CITY OF COSTA MESA

SUBJECT: FIRE STATION NO. 2 RECONSTRUCTION, CITY PROJECT NO. 26-05 - ADDENDUM NO. 1

This addendum, effective on this date, addresses the following items:

- Added Pre-Bid Requests for Information Questions and Answers
- Added PBK Addendum letter dated September 15, 2026
- Revised drawings, specifications, and reference documents

DRAWING NUMBER: **A5.1**

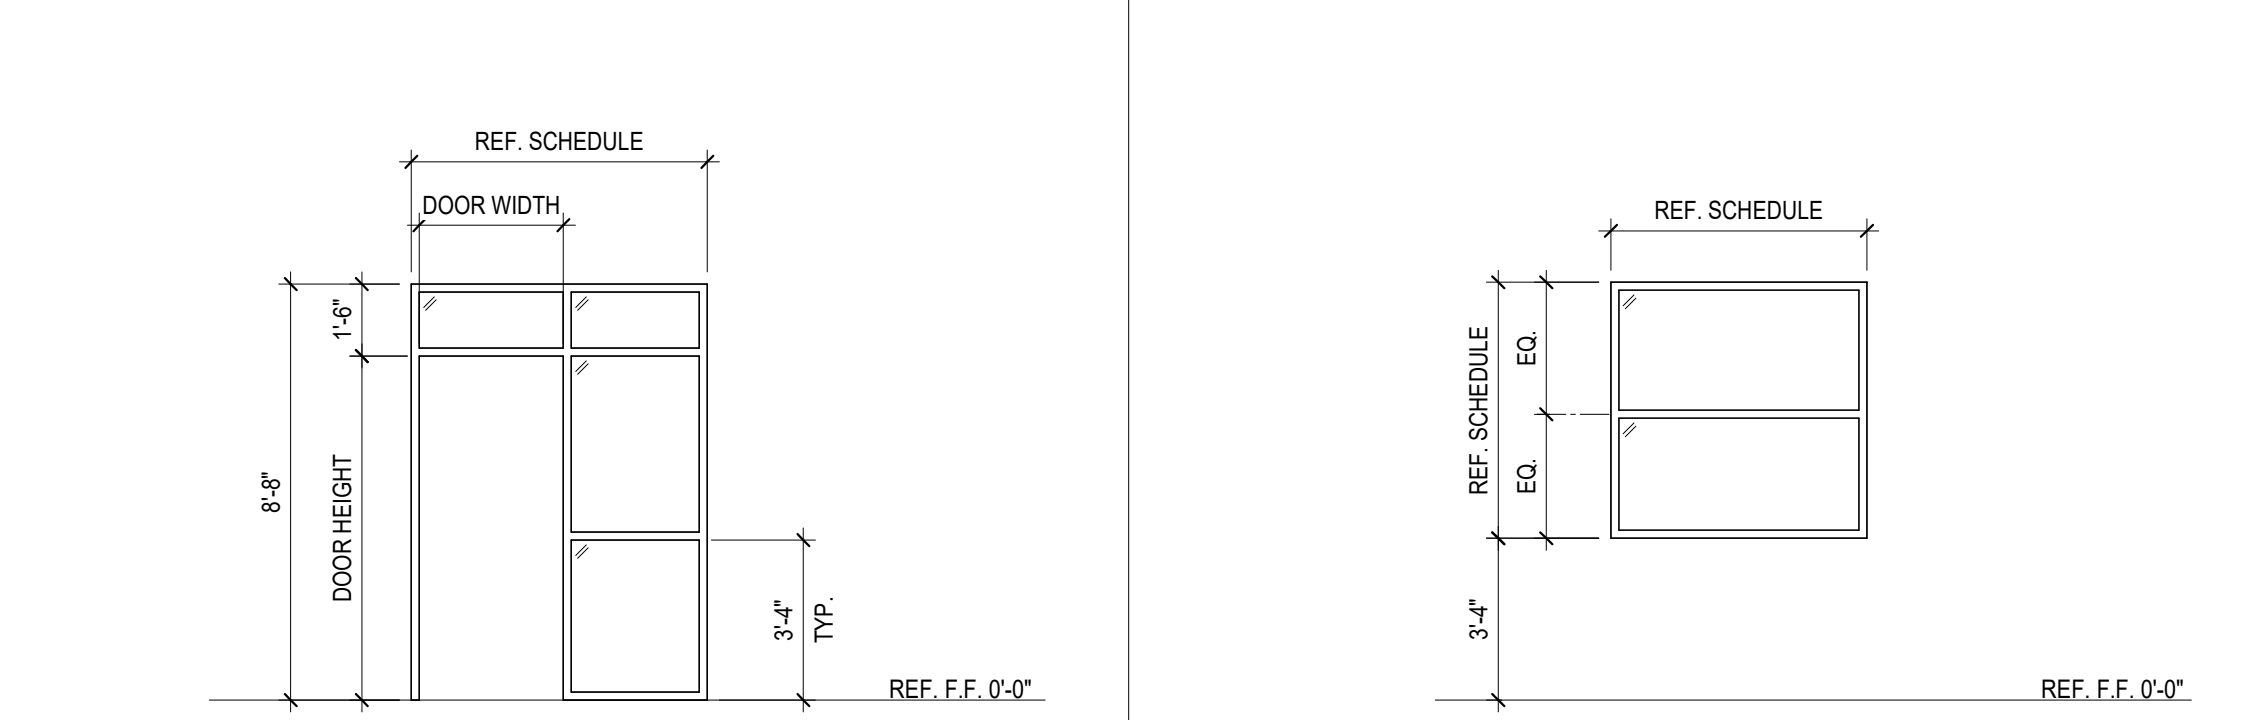
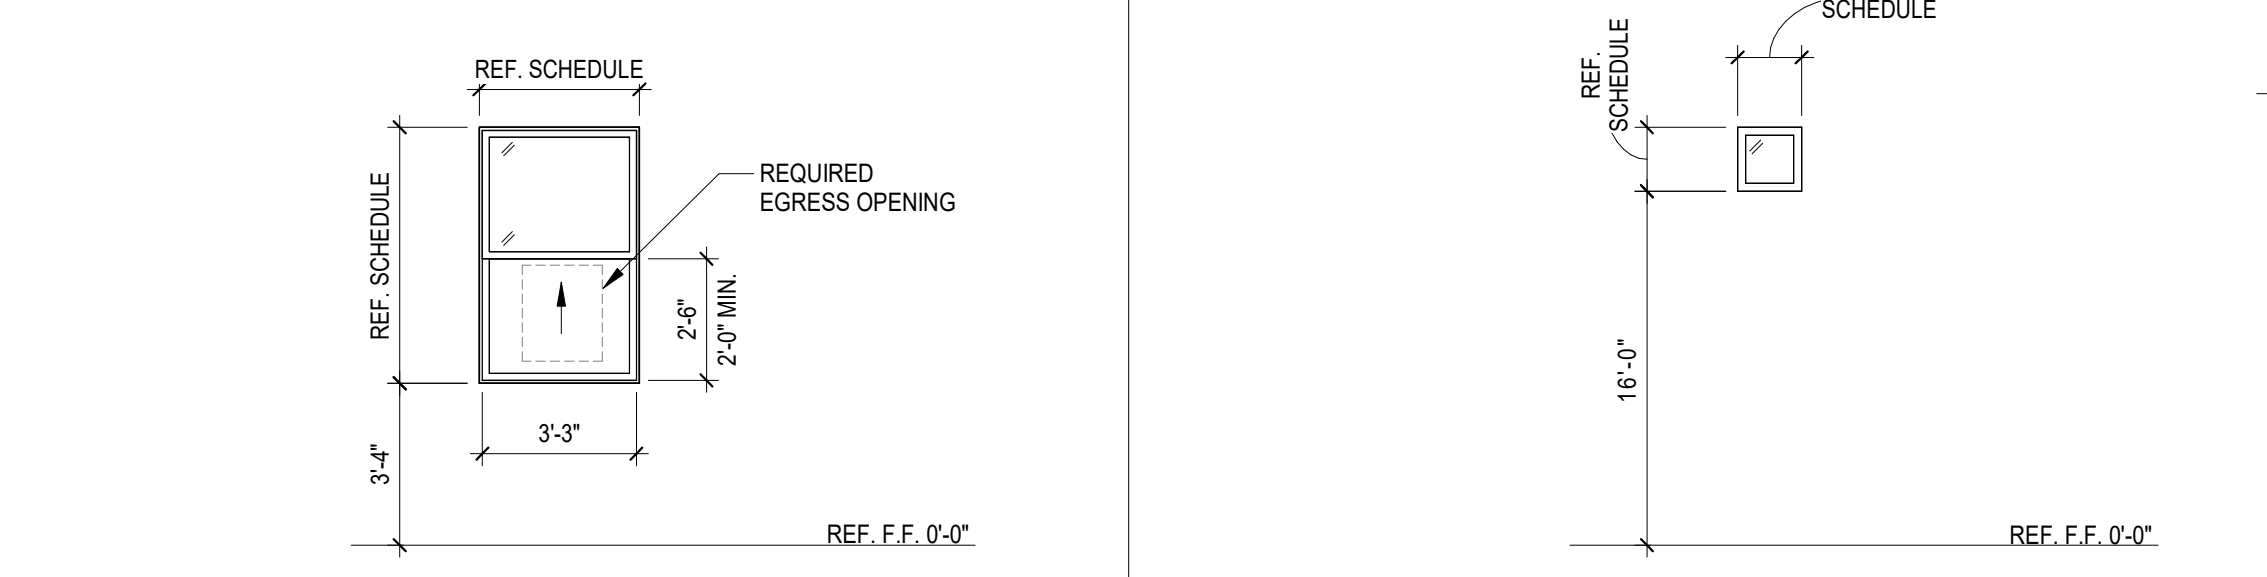
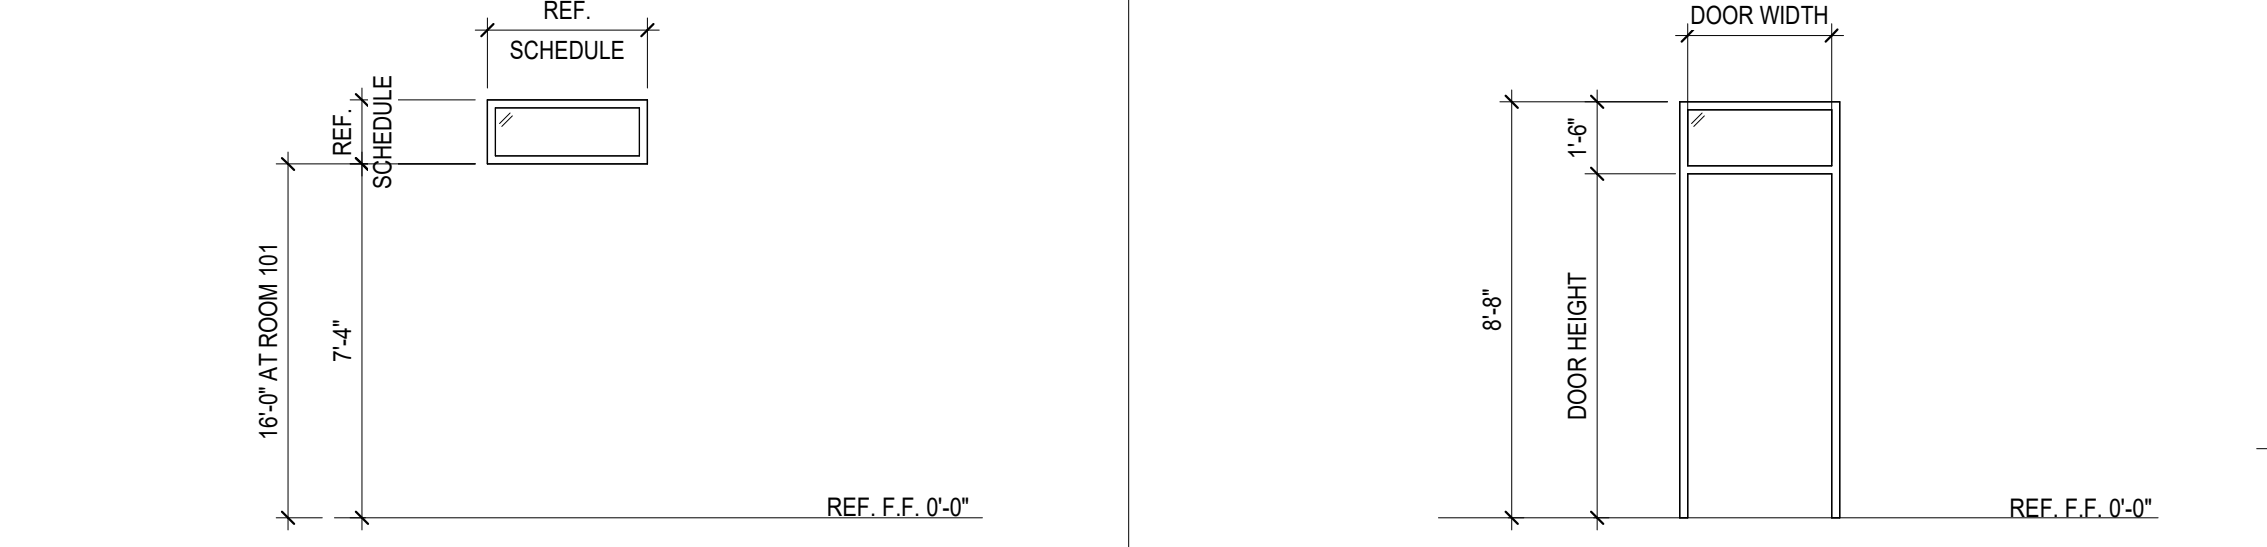
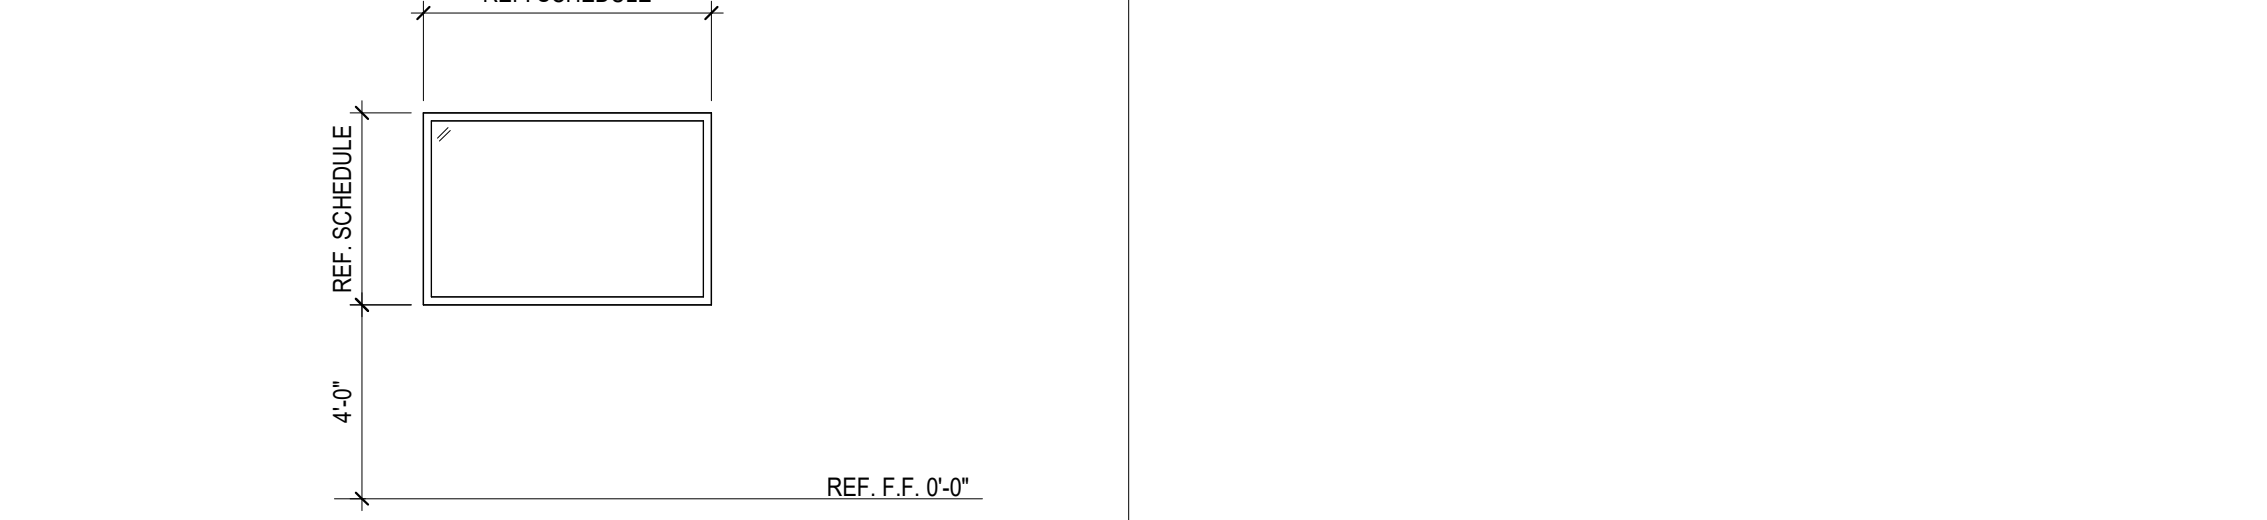
Number	Question	Answer
1	Per drawing A5.1, Window Types C and C1 are shown with Glazing Type F (fire rated safety glass); however, the required fire rating duration for these window assemblies is not indicated. Please confirm the fire rating applicable to Window C and Window C1.	The Window Schedule on Sheet A5.1 has been updated to indicate that Window Type C has a 60-minute rating with Type F glazing. Window Type C1 on the same schedule has been updated to receive Type A glazing and is non-rated.
2	The door schedule on Sheet A5.1 lists Door #129A as 45 minute fire rated, but also shows Glazing Type C, which is ½" non rated clear tempered glass. Please confirm whether fire rated glazing is required for Door 129A.	The Door Schedule on Sheet A5.1 has been updated to indicate that Door 129A has Type F glazing.
3	While looking over the documents, we noticed that there is a need for AV Cabling, but not the actual hardware/installation for these AV systems. Will the AV be bid out as its own separate project?	The AV equipment shown on plan is for the interconnection of TV's and laptops. Detail sheet E3.1, detail numbers 12, 13, and 14 indicate equipment and connections to be provided and installed.

- A. REPLACE: Sheet in its entirety with the attached A1.5. Revisions clouded.
- 1.17 SHEET A5.1 DOOR, WINDOW, AND FINISH SCHEDULE
 - A. REPLACE: Sheet in its entirety with the attached A5.1. Revisions clouded.

DRAWING NUMBER: **A7.3**

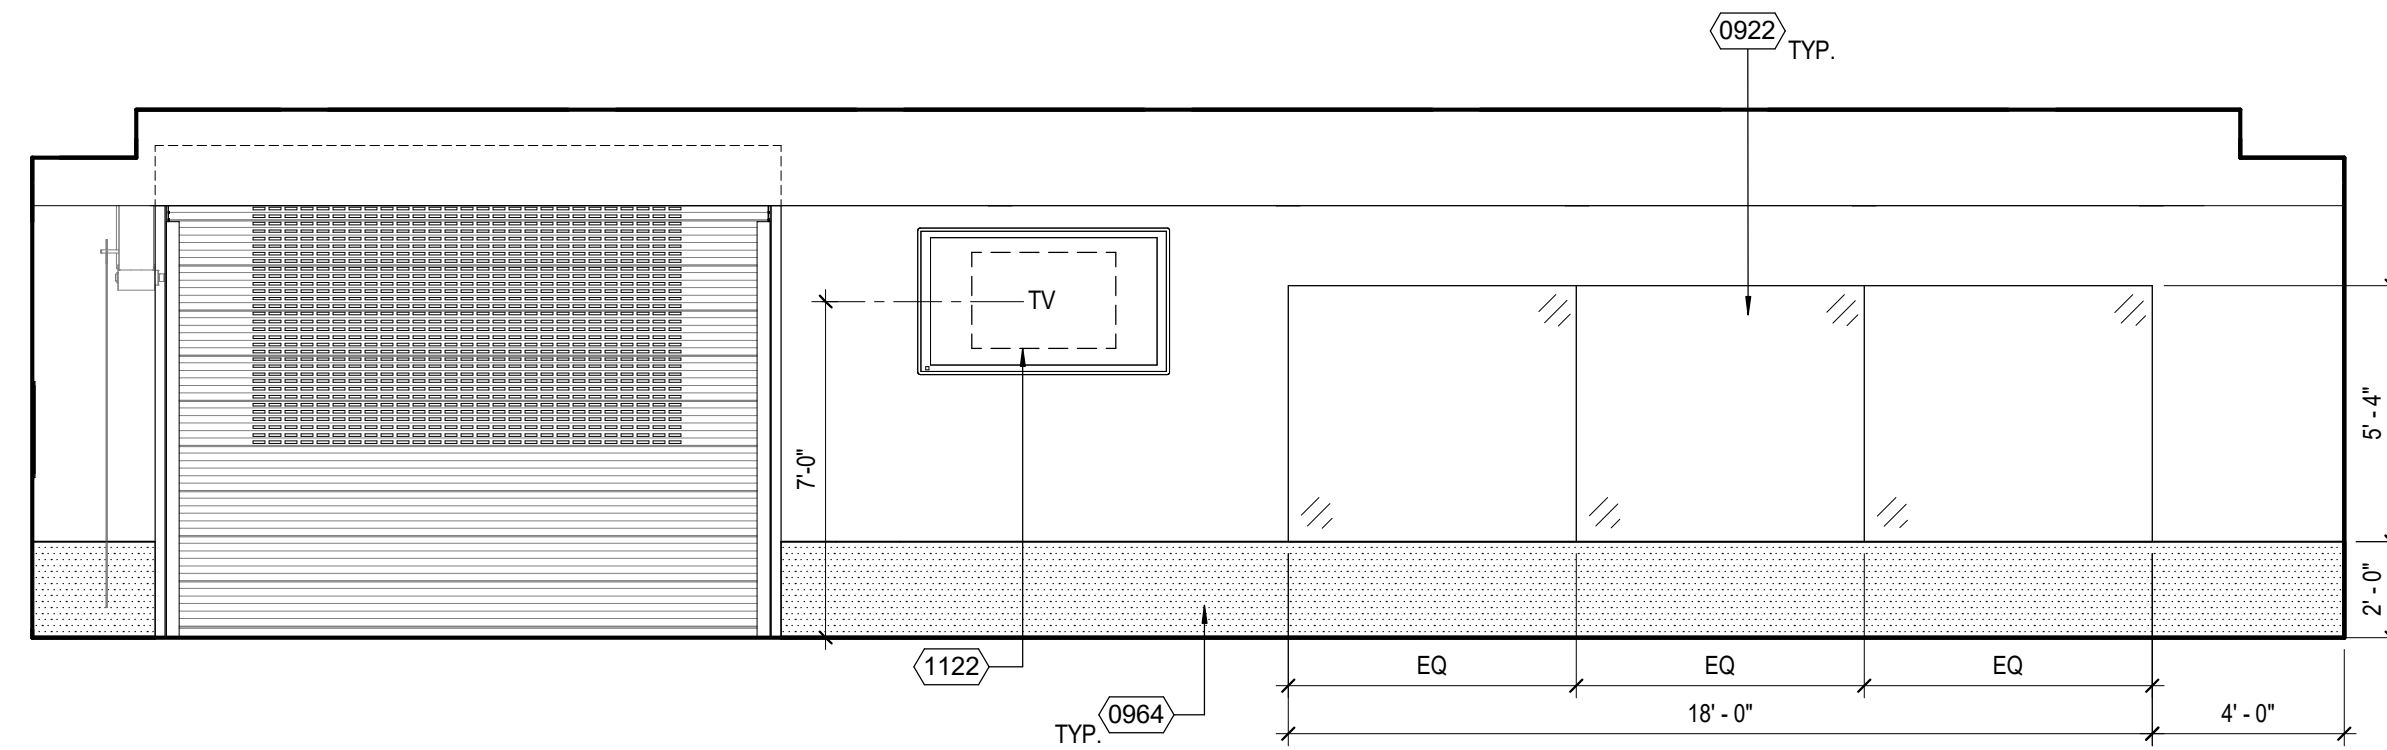
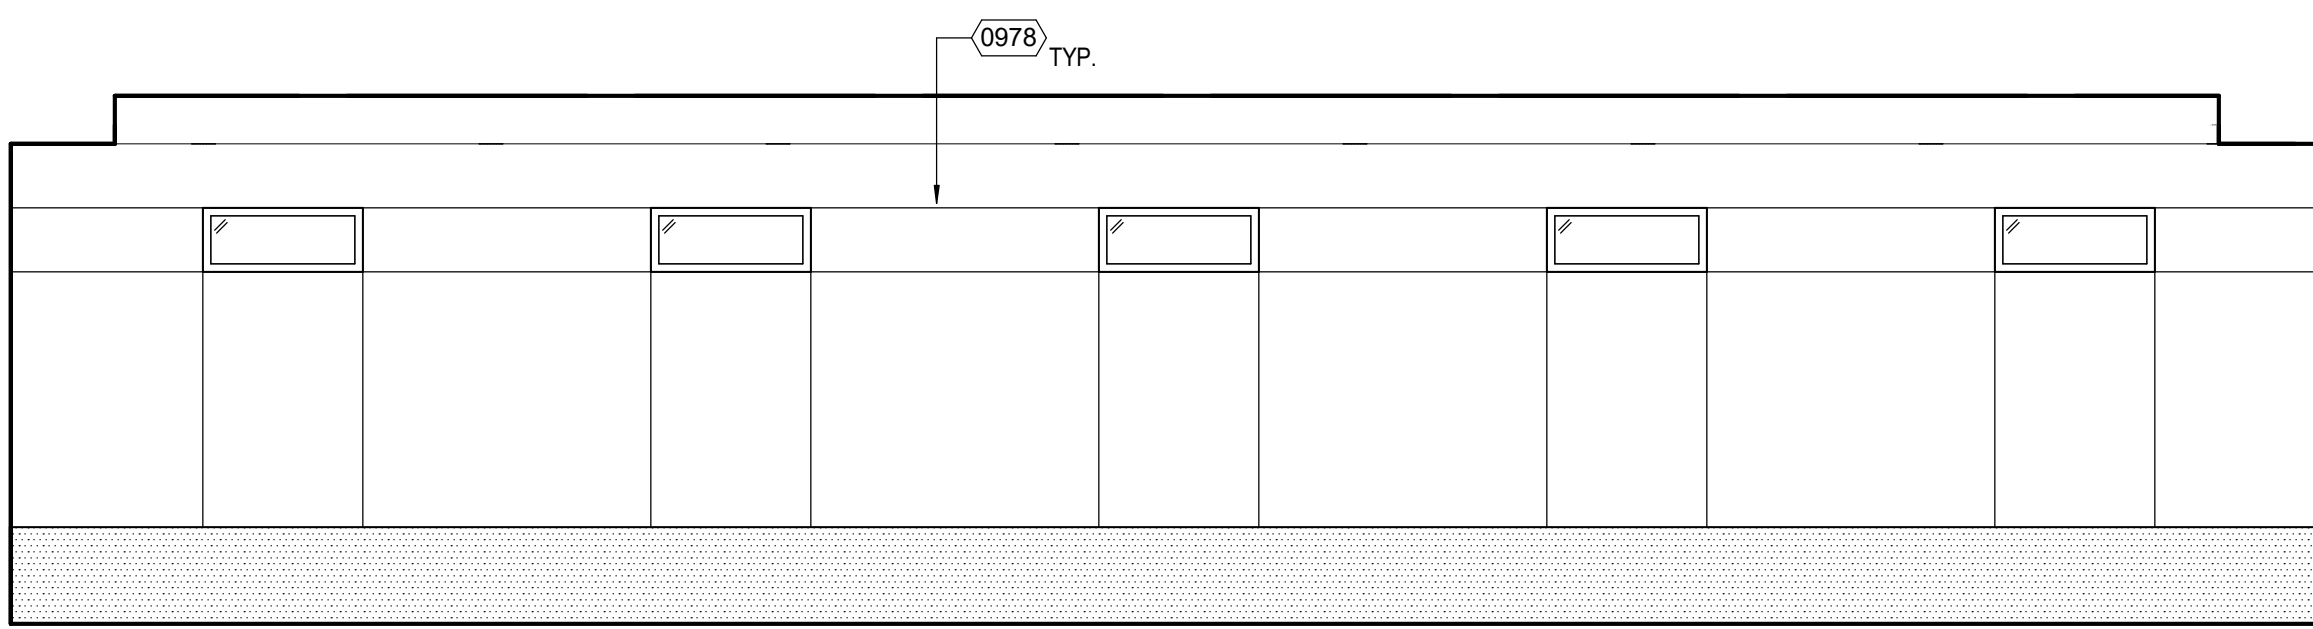
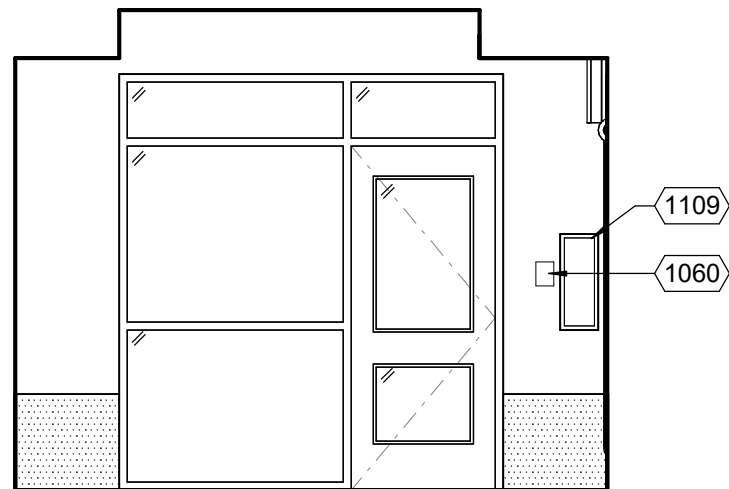
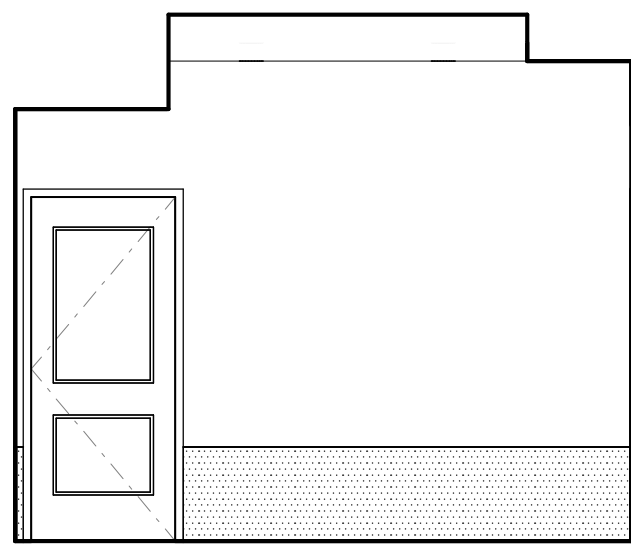
10	Reference Note 0978 on Detail 2 of A7.3 calls for Gypsum Board Reveal per Detail 13/A8.4. Please confirm Reveal Detail should be 14/A8.4 and not 13/A8.4	Confirmed. The correct detail callout for Keynote 0978 should be 14/A8.4.
11	Please confirm that all HCD plan review, permitting, inspection, and related fees associated with the Temporary Living Quarters are to be included in the Contractor's Base Bid.	Confirmed.
12	Please confirm whether the temporary electrical service shown on Sheet A1.0_B is adequate to serve both the Temporary Living Quarters (WillScot or equal) and Temporary Apparatus Bay (ShelterLogic ShelterTech SP Series or equal), as specified. If not, please identify any additional electrical equipment or service upgrades required to support these temporary facilities.	Refer to the residential calculations provided on the approved plans, which include the residential appliances factored into the calculations. Based on these calculations, the designed temporary electrical service is sufficient to energize the living quarters and temporary apparatus bay.

- A. REPLACE: Sheet in its entirety with the attached A7.3. Revisions clouded.
- 1.22 SHEET 7.4 INTERIOR ELEVATIONS
 - A. REPLACE: Sheet in its entirety with the attached A7.4. Revisions clouded.

DRAWING NUMBER: **A8.7**

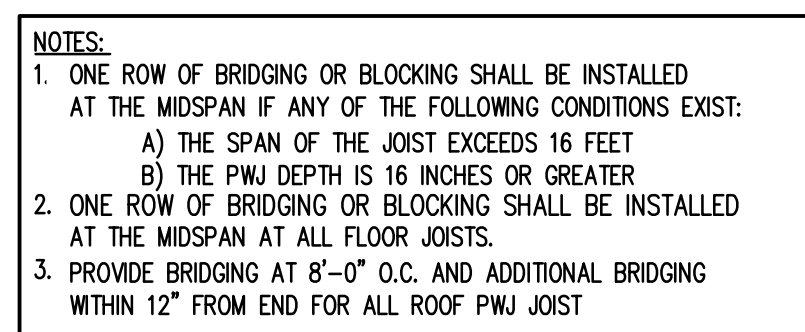
56	Sheet A8.7 references membrane roofing; however, no standalone Section 07 50 00 is included in the Project Manual. Please confirm whether these conditions are governed by Section 07 52 00 SBS Modified Bituminous Roofing, Section 07 13 53 Elastomeric Sheet Waterproofing, or another roofing/waterproofing system. Provide the required manufacturer, product, membrane thickness, number of plies, attachment/application method, flashing, terminations and warranty. References: Division 07 Table of Contents; Sheet A8.7; Sections 07 13 53 and 07 52 00.	Specification Sections 07 52 00 and 07 13 53 are to be used in conjunction as required.
58	Sheet A2.3 identifies GAF Timberline HDZ Reflector Series, color Aged Chestnut, while Section 07 31 13 permits multiple Timberline-family products. Please confirm the exact asphalt-shingle product that governs the base bid and confirm the final required color. References: Sheet A2.3; Section 07 31 13.	Aged Chestnut is the basis of design. To maintain the LEED credits awarded during the design phase, the selected roofing product for the asphalt shingle roof must have a minimum 3-year aged SRI of 16 and the modified bitumen roof must have a minimum 3-year aged SRI of 85.

- 1.23 SHEET 8.7 ROOF DETAILS
 - A. REPLACE: Sheet in its entirety with the attached A8.7. Revisions clouded.
